UNITED STATES ENVIRONMENTAL PROTECTION AGENCY
REGION 5

Re: Comments on the submittal of the Lockformer Work Plan required under the Unilateral Administrative Order (UAO) Docket No. V-W-02-C-665 issued to Lockformer Company and MET-COIL Systems Corporation.

Re: Review Comments on the Removal Action Work Plan
The Lockformer Company, Lisle, Illinois

FIGURE
2.2-1

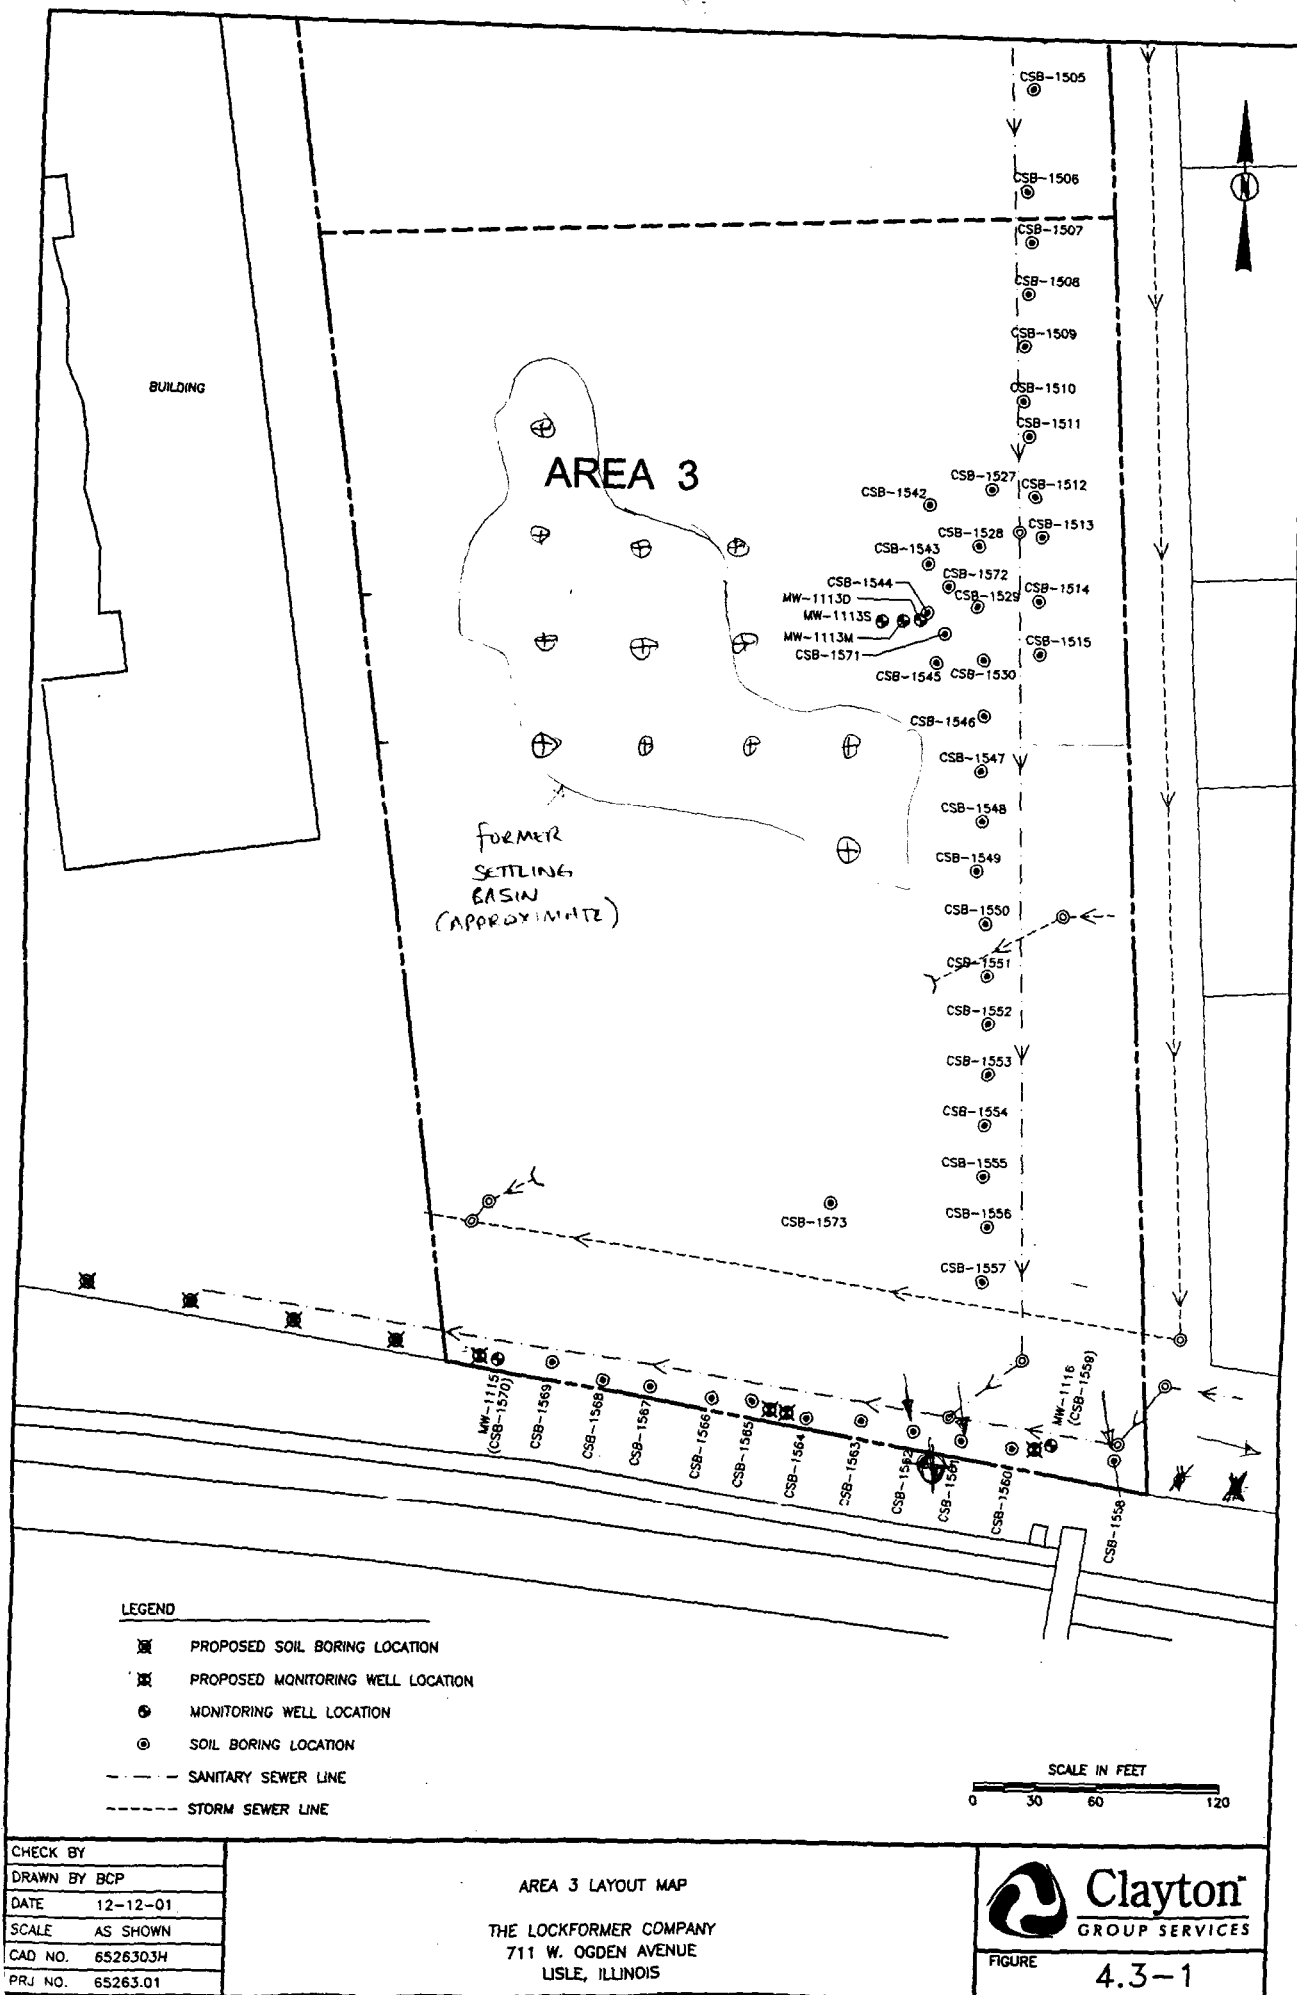
1. The concentration units indicated on Figure 2.2-1 are mg/kg; however, Table 2.2-1 units are in micrograms per kilogram (ug/kg). Please revise as appropriate. In addition, significant deviation is noted between samples analyzed using field gas chromatography (GC) and those that were laboratory-analyzed. Although the field GC results seems to be conservative based on the values presented, the quality of both the laboratory and field GC data are questionable due to such high differences in the data.

For boring CSB-1558, the boring log indicates a sample was collected for VOC analysis from 2 to 4 ft bgs; however, the sample results have not been provided on Figure 2.2-1 nor in Table 2.2-1. In addition, Figure and Table 2.2-1 indicate a sample collected from 22 to 24 ft bgs; however, the boring log indicates the sample was collected from 20 to 22 ft bgs. Please revise as appropriate.

**SURFACE DRAINAGE WAY SAMPLING MAP
THE LOCKFORMER COMPANY / Lisle, ILLINOIS**

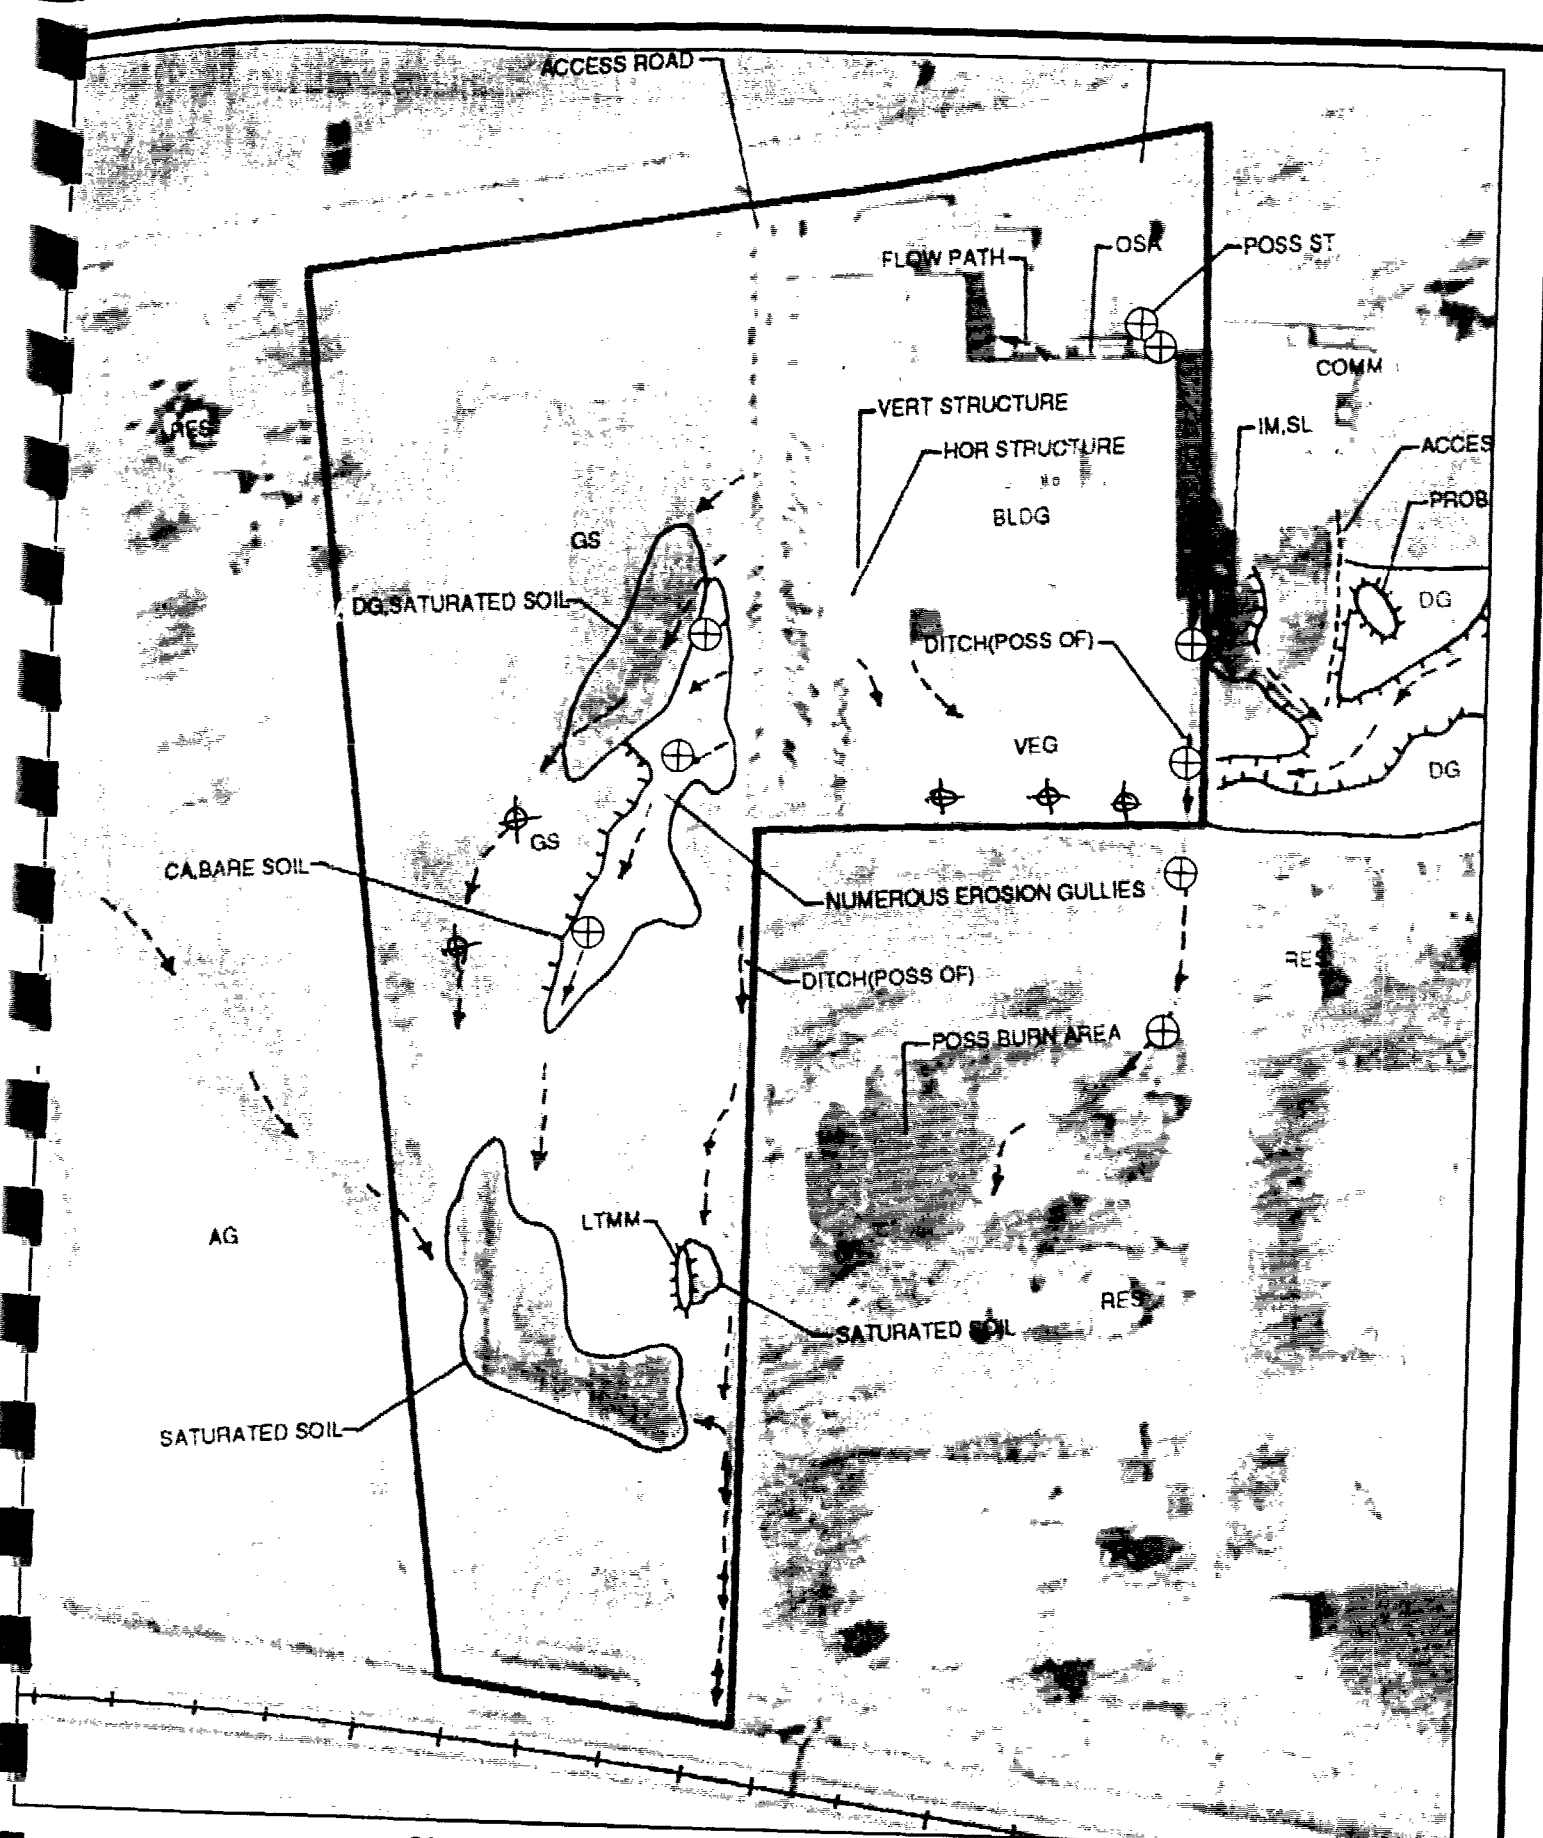
3. Page 1-4: A discussion of the historical drainage features of the site should be included as the last paragraph in the subsection. The discussion should include locations of and flow directions within the historical drainage features depicted on Figure 4.4-1.

FIGURE 4.4-1

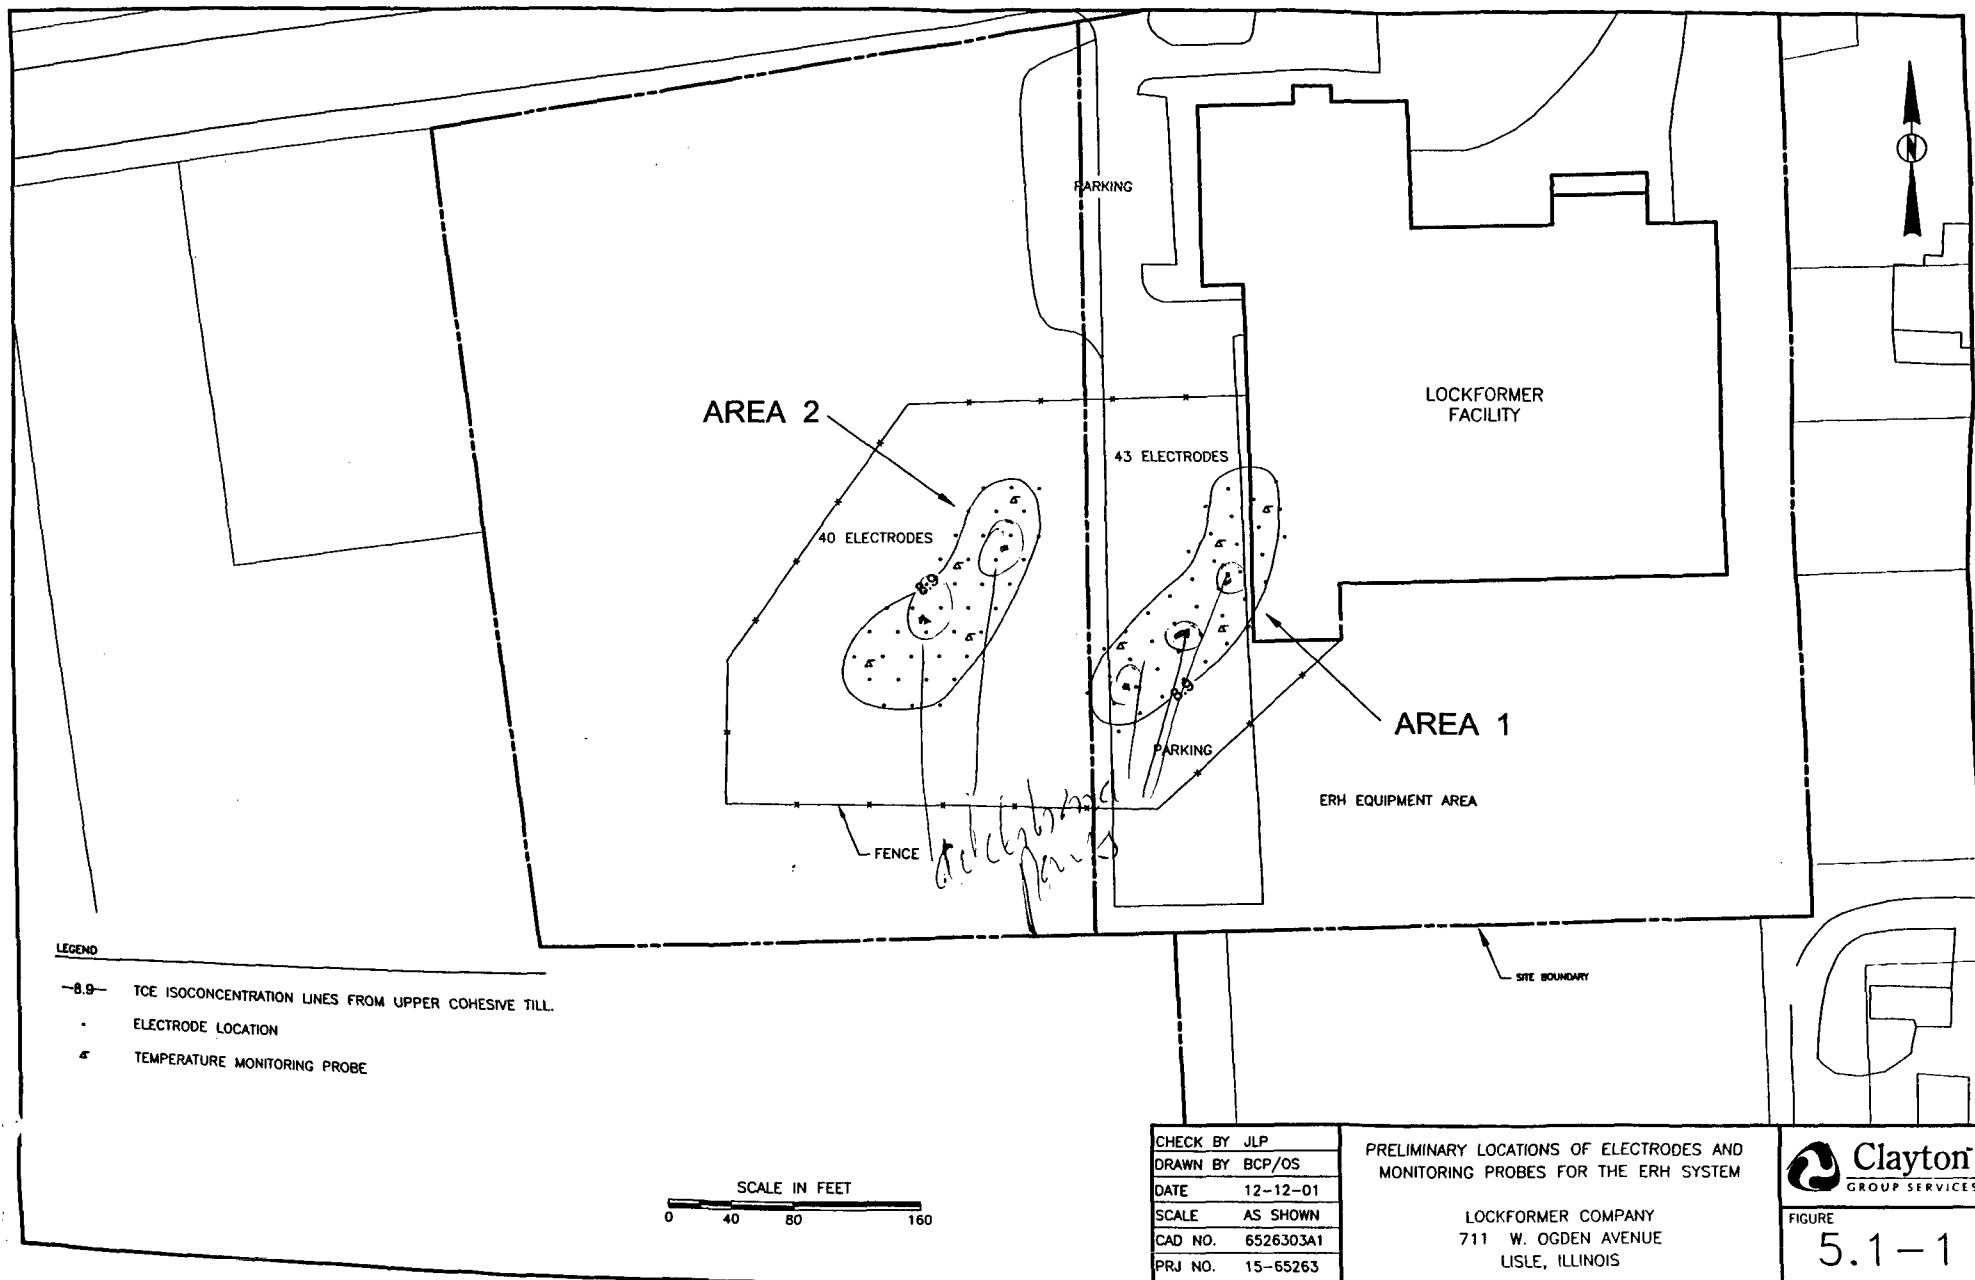
- d. Due to evidence of historical fill placement in the southern portion of Area 1, three borings should be advanced along the southern boundary of Area 1 (as indicated in Figure 4.4-1 of Attachment A). These borings should be advanced into the upper portion of the lower clay/silt unit (unless groundwater is encountered prior). The easternmost boring should be advanced to bedrock to define geology in this area. Sampling of these borings should parallel sampling of the upper clay till/fill and mass waste units to define areas requiring treatment via ERH and SVE, respectively (e.g., one sample per 8 ft if using direct-push technique).

2. Historically, a settling basin was present in the central portion of Area 3 (see Figure 4.4-1). The surface water drainage way sampling should include investigation of this area since it may have served as a sink for TCE released at the site. Recommended boring locations are based on a grid with traverses spaced at 50 ft, as indicated on the **attached Figure 4.4-1 in Attachment A**. Prior to the investigation, an evaluation to estimate the depth of fill placed in this area and to determine the historical elevation of the settling basin should be performed based on historical topographical maps. Since the mass waste unit may have historically been the surface soil in this area, thereby facilitating rapid vertical migration of contaminants, all borings should be advanced into the upper portion of the lower clay/silt unit.

3. In general, a 16-ft boring depth seems appropriate for borings located in Area 1 and offsite to the east, provided the vertical extent of contamination (if present) is delineated. Due to placement of fill on Areas 2 and 3, an evaluation of historical topographical maps to current site conditions should be performed to verify that a 16-ft boring depth is appropriate for the borings proposed in Areas 2 and 3.
4. Figure 4.4-1: All proposed borings should be labeled using unique identifiers.
